Subject: Applicant's Response to Data Requests, Set 2B (#173-185)
Rio Mesa Solar Electric Generating Facility (11-AFC-04)

Applicant's Response to Data Requests, Set 2B (Nos. 173-185)

**Rio Mesa Solar Electric
Generating Facility
(Rio Mesa SEGF)**

(11-AFC-04)

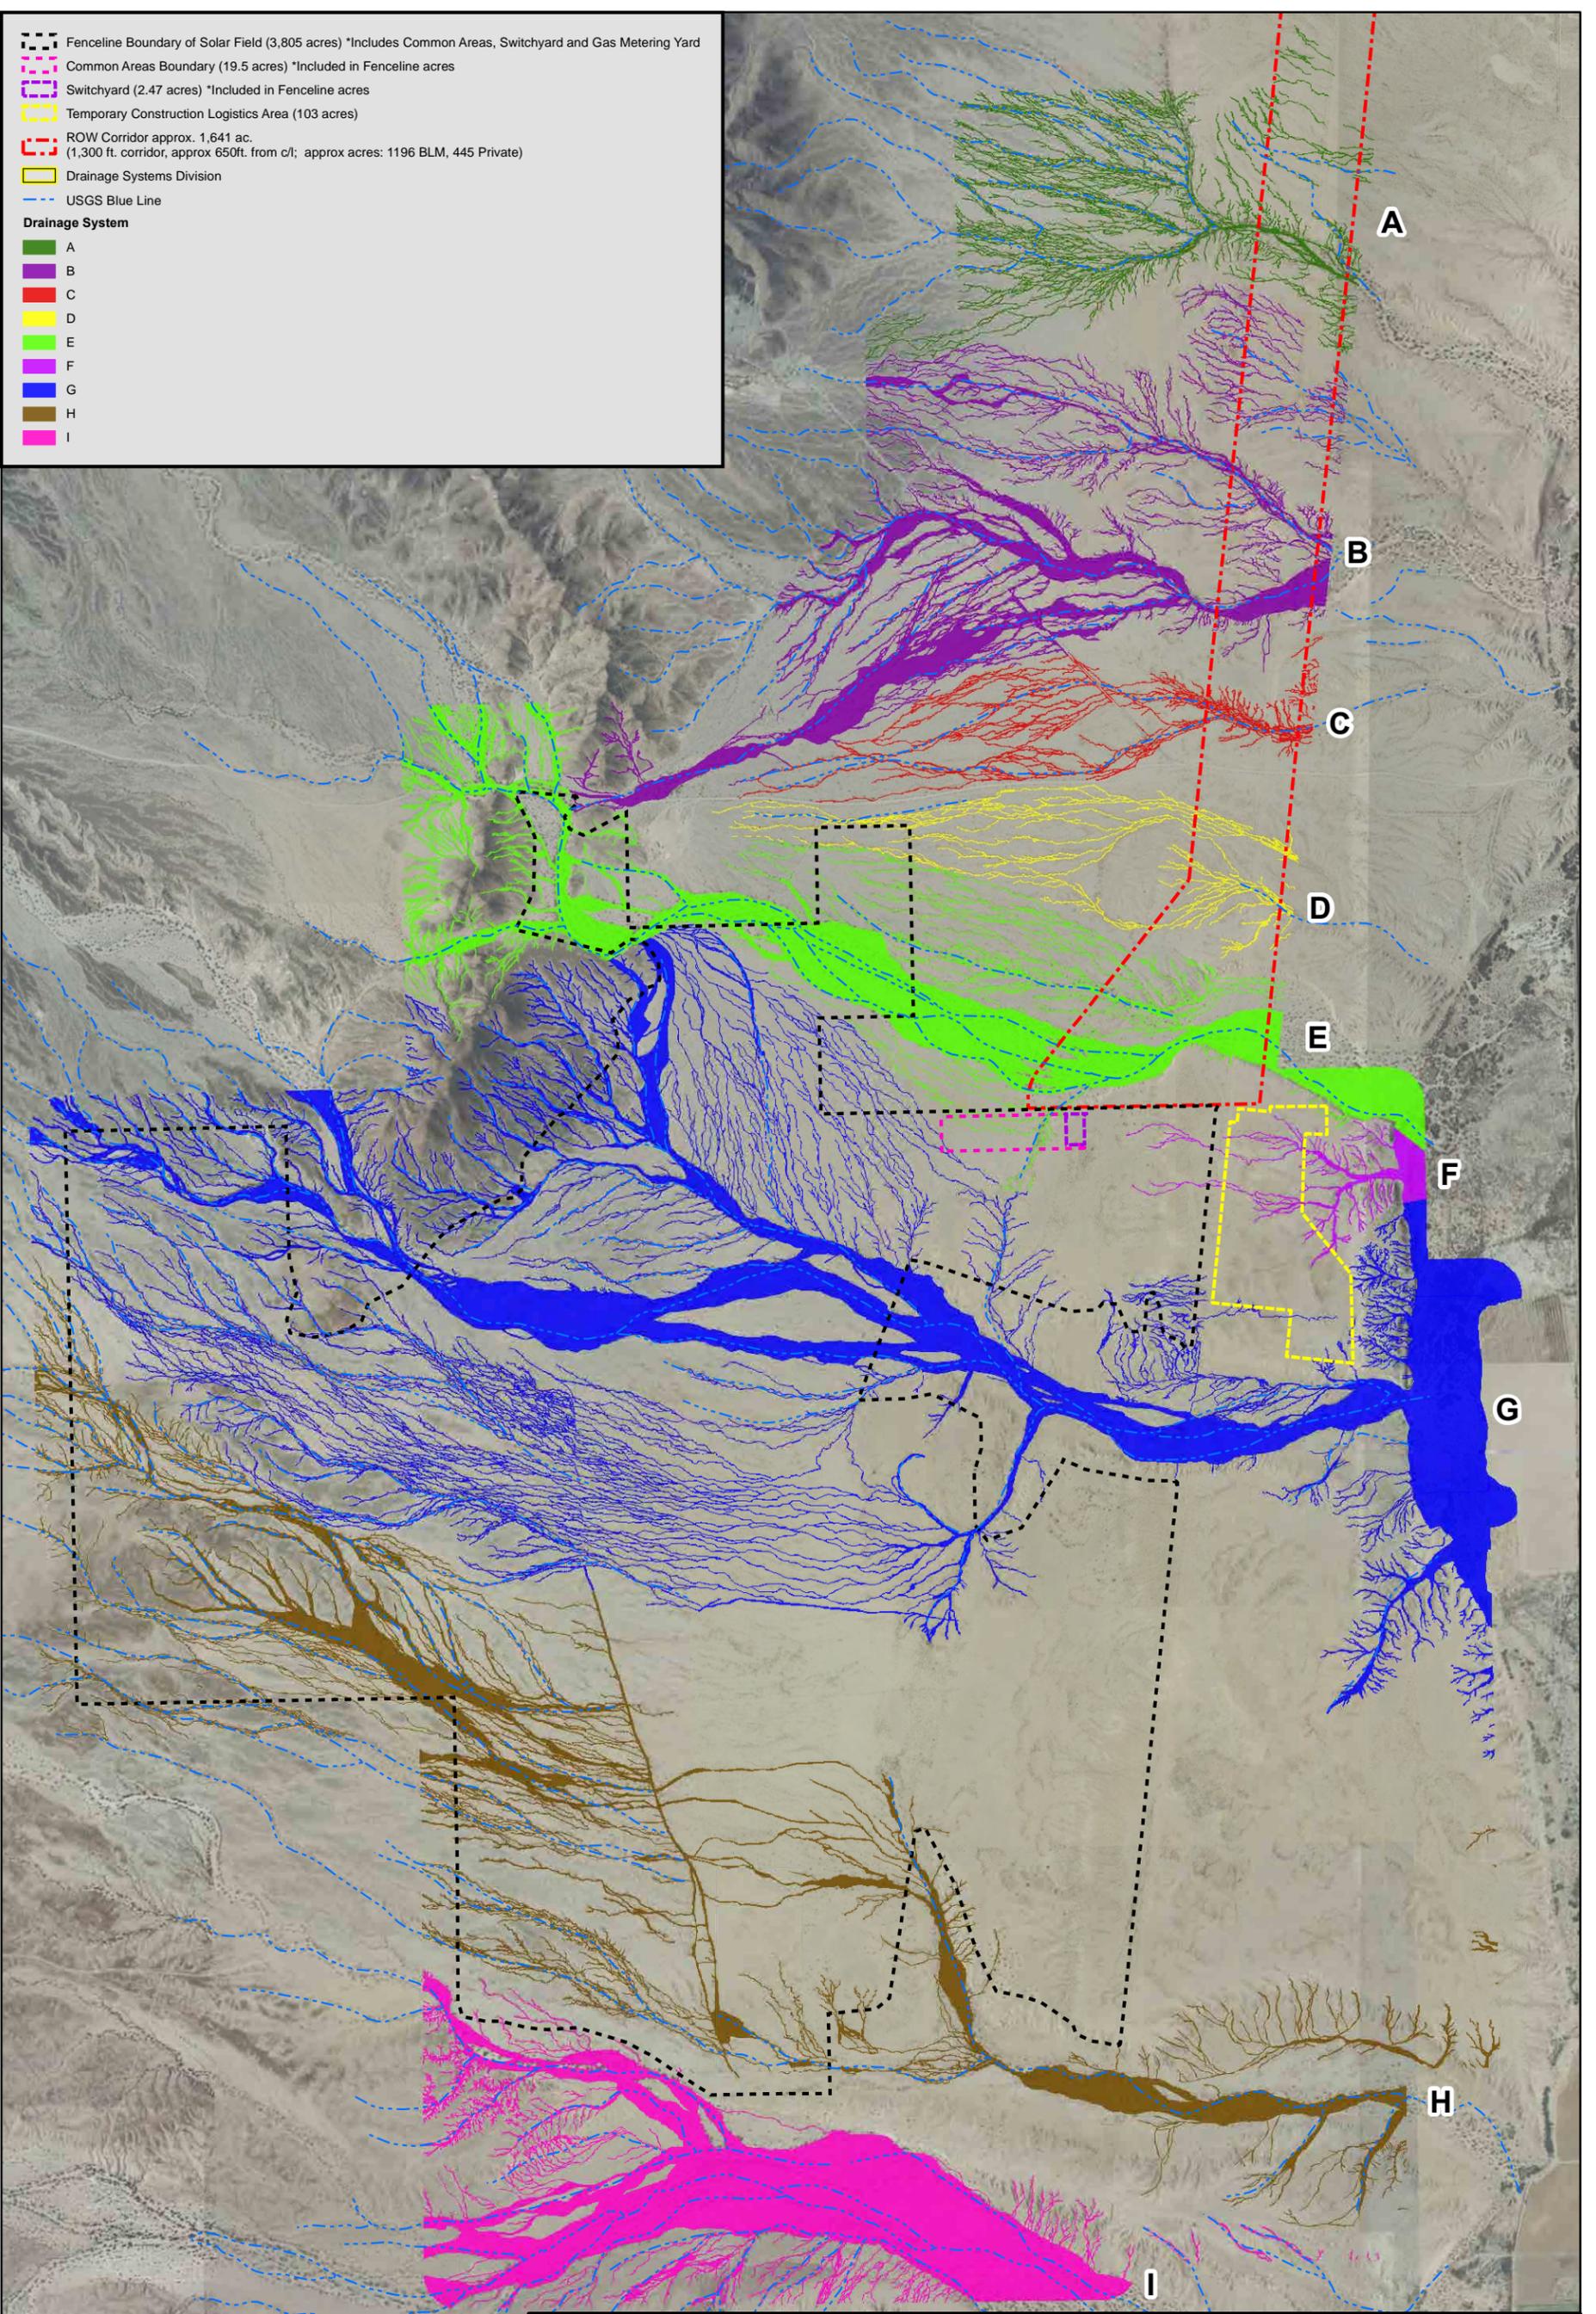
184. *Please provide an updated figure that shows the waters of the U.S. overlain with an outline of the revised proposed project.*

See Attachment DR 184-1.

The Applicant foresees no feasible project alternative that could completely avoid all waters of the US and still satisfy the project objectives. As shown in Attachment DR 184-1 from the Formal PJD acceptance from the ACOE, drainages and fingers of Waters of the US flow throughout the site. The Applicant has made a concerted effort from conception to avoid the main washes (e.g., Drainage I and Drainage E) and continues to avoid washes as feasible. In fact, one of the Applicant's proposed access roads was moved to avoid potential impacts to Drainage G through continual coordination with the ACOE. The Applicant in the original three tower project was able to minimize the number of impacts to Waters of the US down to 28.2 acres. With the elimination of unit 3 and the change to the access road this number will likely go down even further. These new estimations of impacts will be included in the Applicant's Environmental Enhancement Filing to come to the CEC in July.
